SKI report 2008:23
SSI report 2008:04 E

SKI's and SSI's review of SKB's safety report SR-Can

March 2008

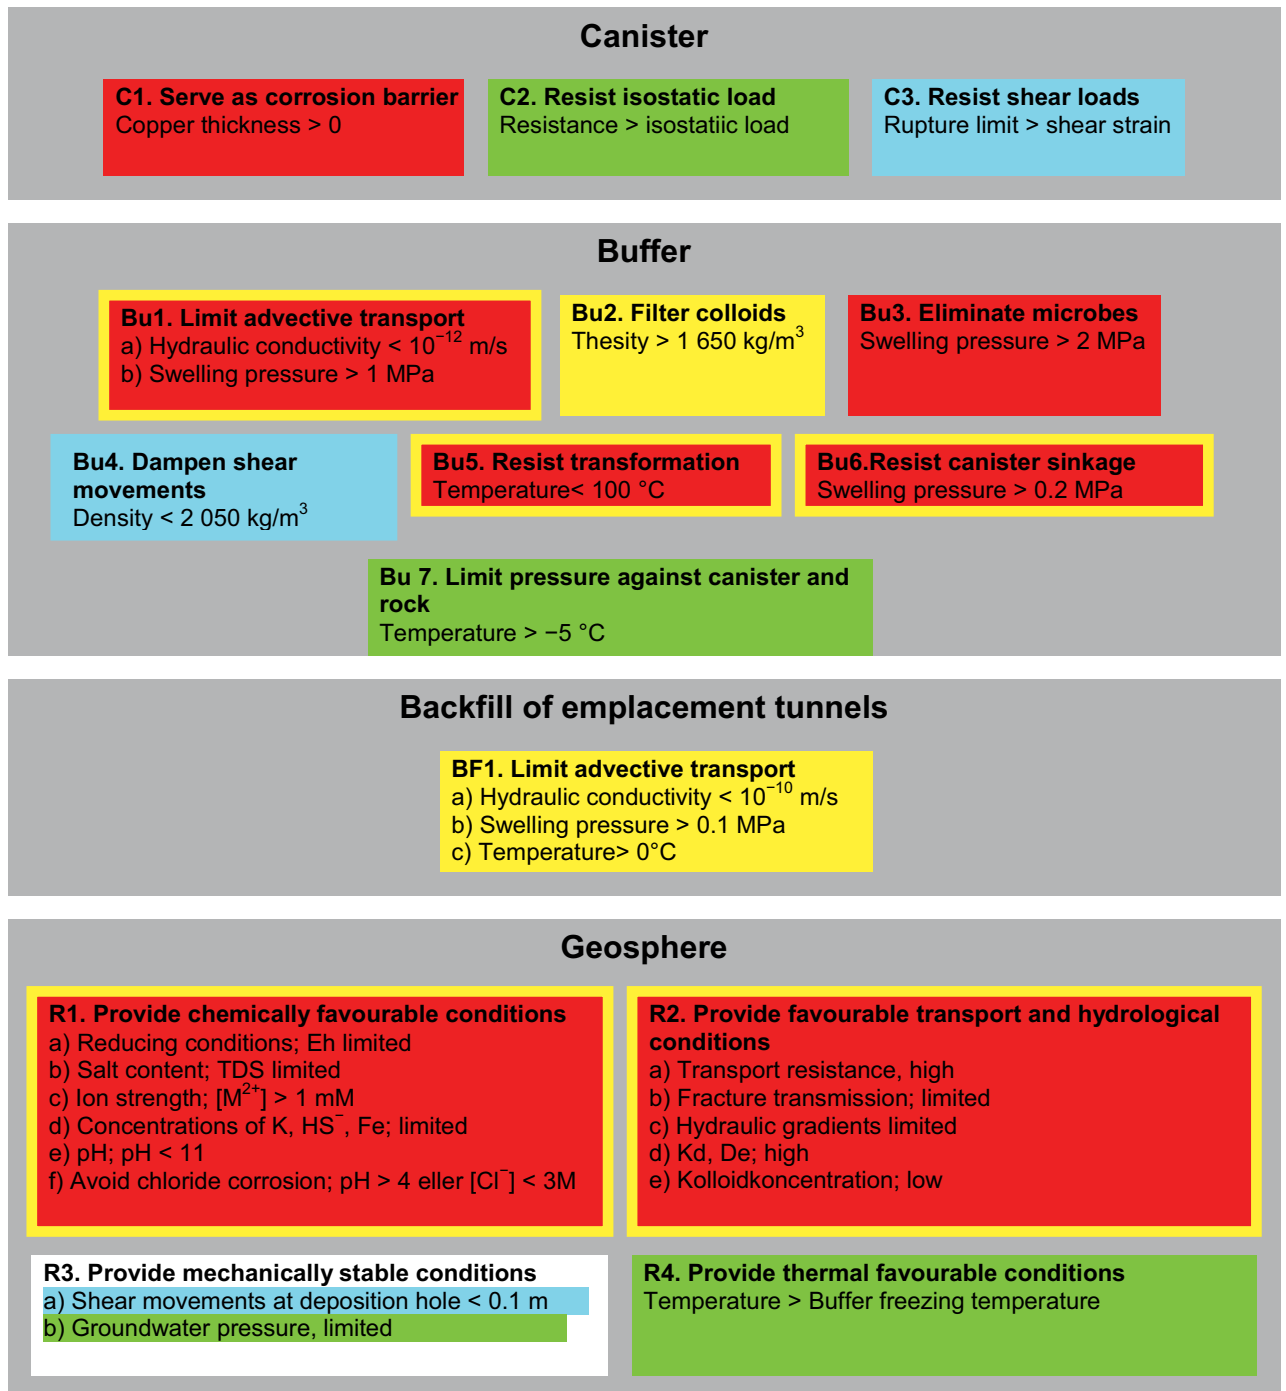
SAM considers that SKB should describe more explicitly how the different barriers contribute to the safety functions isolation and retardation. A report of this kind should include the relative importance of the barriers in different scenarios, and their importance to show that the repository system has a built-in reserve capacity. SAM considers that the analysis of the safety function indicators is a good complement to the analysis of radionuclide transport.
